## **Comments and Responses to Comments on the EA/Draft EIR**

None of the comments received on the EA/Draft EIR for the Lewiston–Dark Gulch Rehabilitation Site: Trinity River Mile 105.4–111.7 (project), or the lead agencies’ responses to these comments, constitute significant new information that would require recirculation of the EA/Draft EIR, as set forth in CEQA Guidelines Section 15088.5. More specifically, none of the new information reveals any significant environmental effects not previously identified or any substantial increase in the severity of any previously identified effects. For these reasons, the TCRCD, the CEQA lead agency, directed that an EA/Final EIR be prepared.

### ***2.3 Comments and Responses to Comments on the EA/Draft EIR***

**Figure 3.7-4c**  
**Revised - Impacts of Proposed Action to Jurisdictional Waters of the United States**

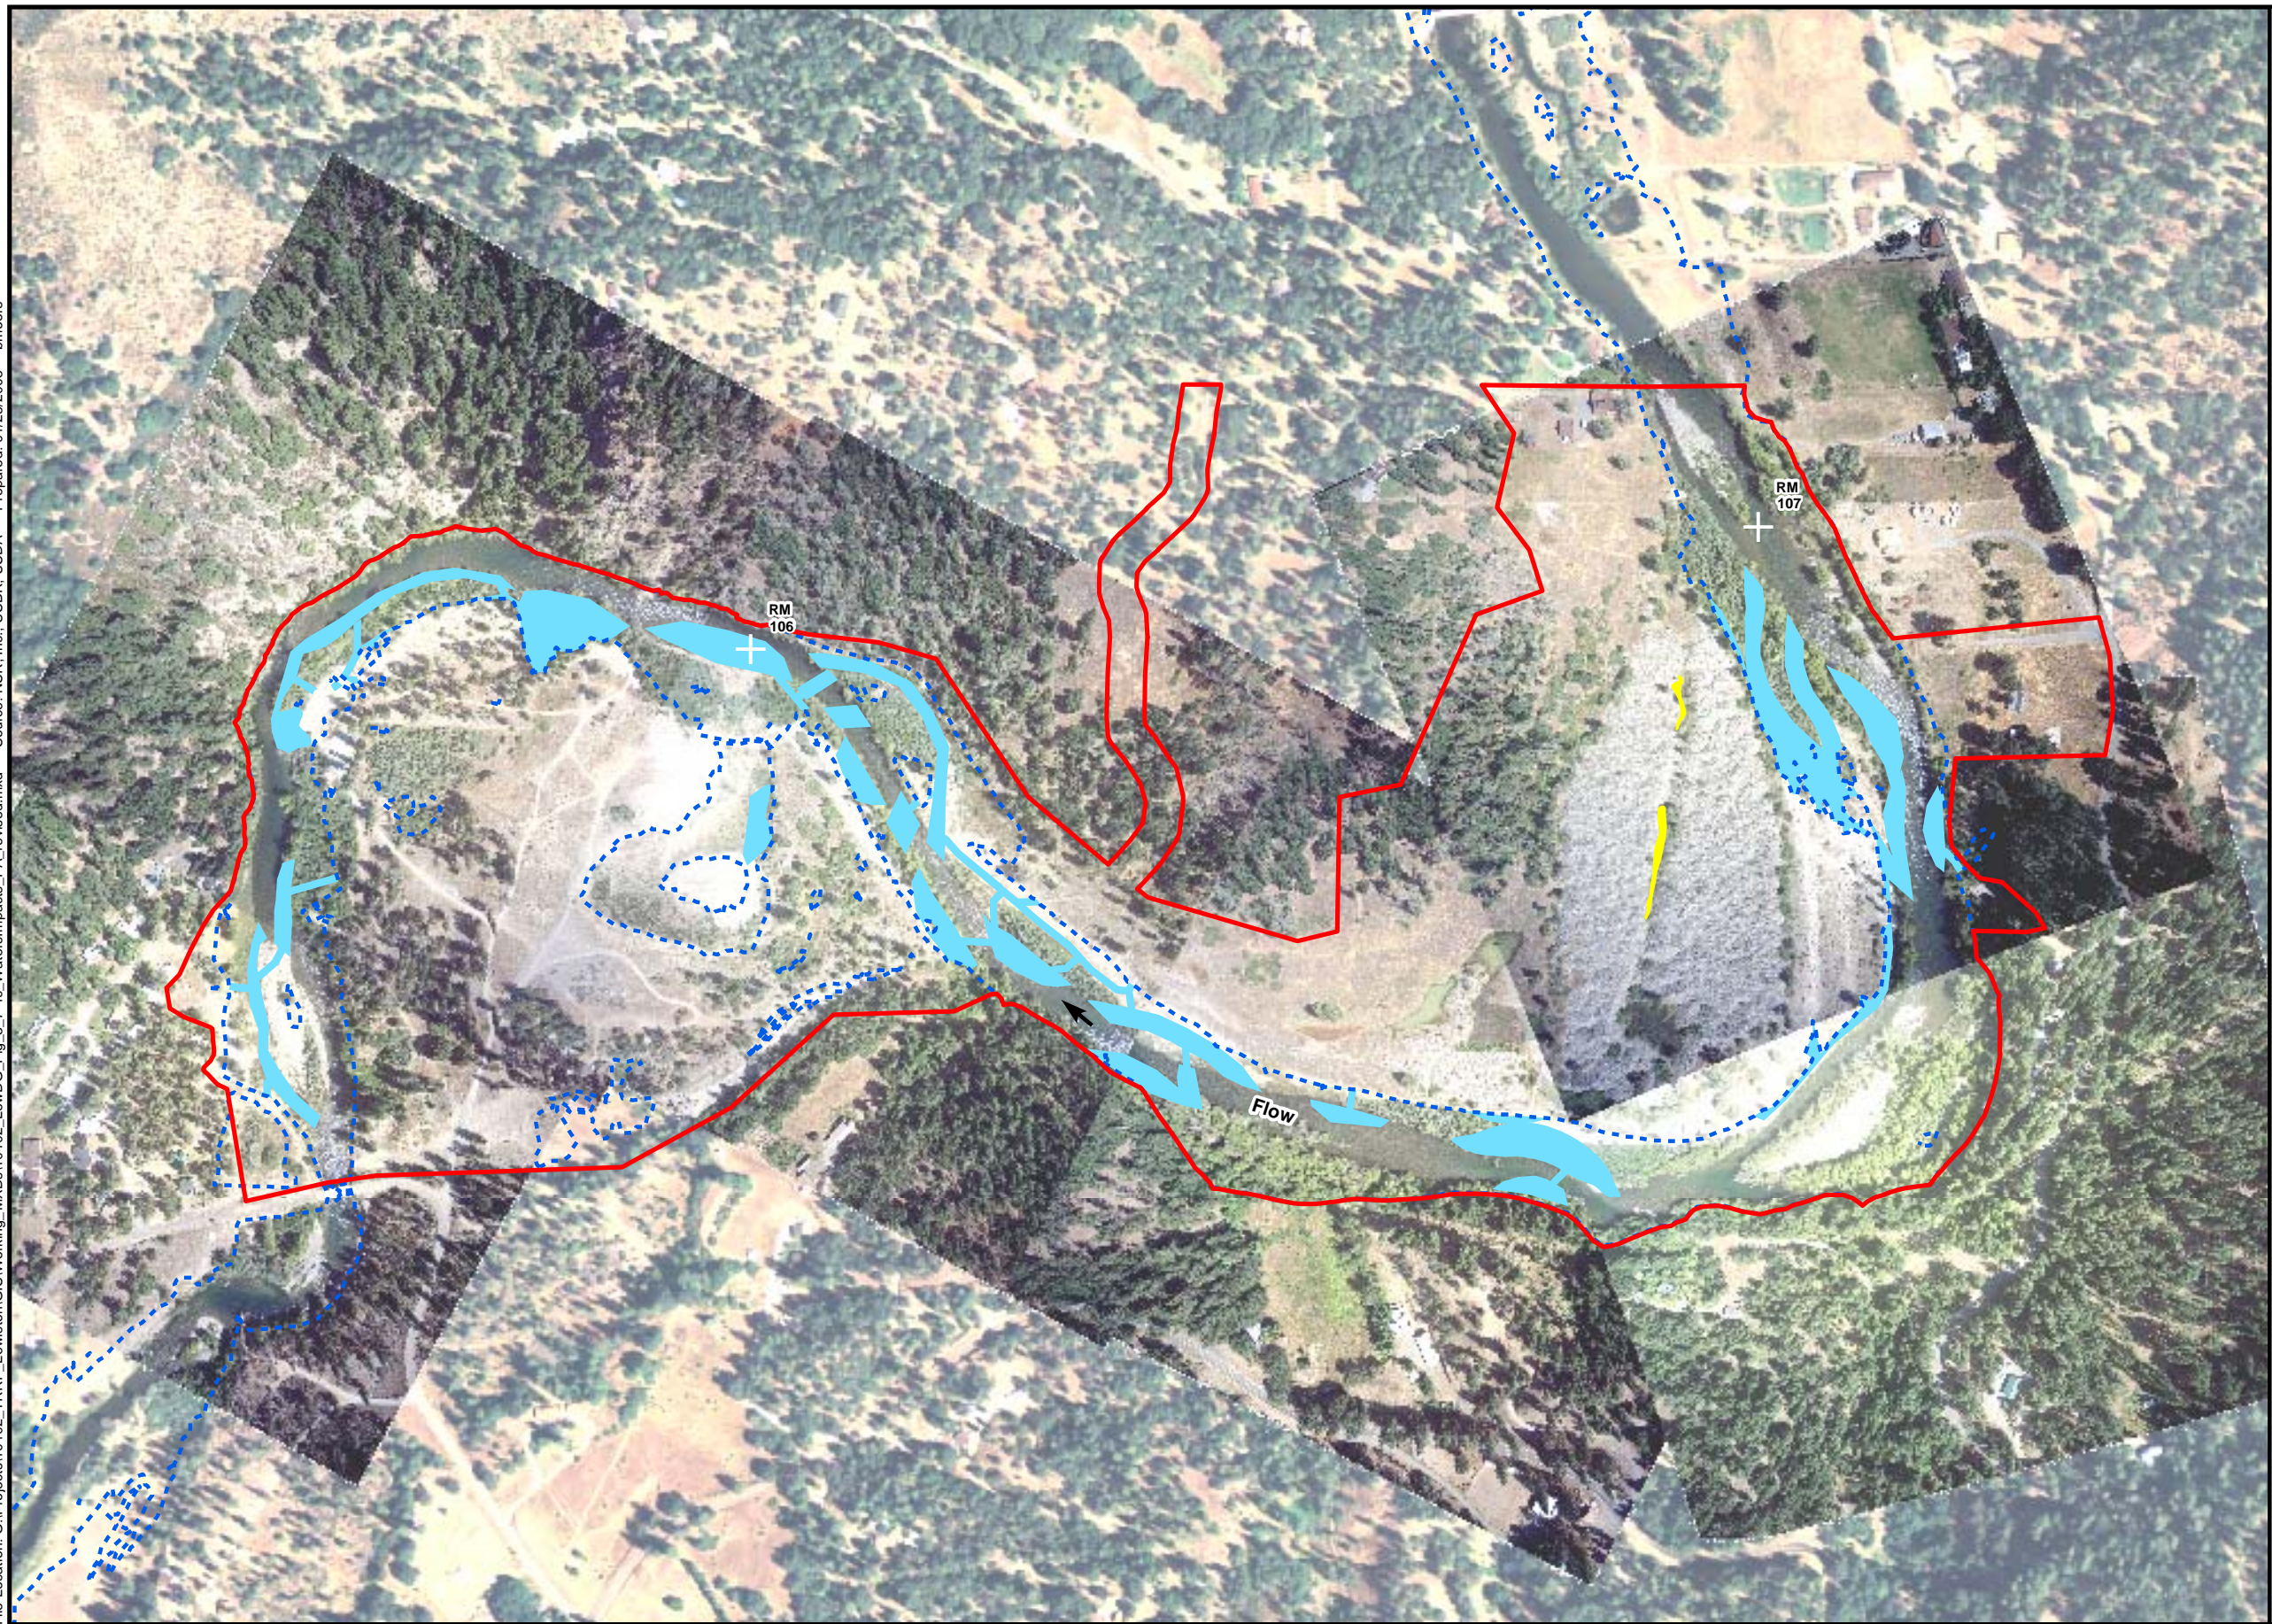
Table 3.7-6 summarizes areas of disturbance to jurisdictional waters, including riparian wetlands. The data in this table are not consistent with the data illustrated on Figures 3.7-4 a, b and c, which show spatial impacts to riparian wetlands. Furthermore, the impact areas illustrated on the figures appear to conflict with the acreages listed on those figures. Thus it is unclear what the projects' impacts to riparian wetlands will be.

Construction activities associated with the Proposed Action would result in temporary impacts to jurisdictional waters, including wetland features, within the sites (Revised Figure 3.7-4 c). Revised Table 3.7-6 lists acres of jurisdictional waters that would be affected by the Proposed Action. Construction of the Proposed Action would result in a direct temporary impact to 28.55 ~~22.50~~ acres of jurisdictional waters. Temporary impacts to jurisdictional waters would be considered significant.

Figures 3.7-4c and 3.7-5c on pages 3.7-49 and 3.7-52 of the EA/Draft EIR have been revised to reflect changes in wetland impacts that resulted from the USACE verification. These revised figures are included at the end of this chapter.
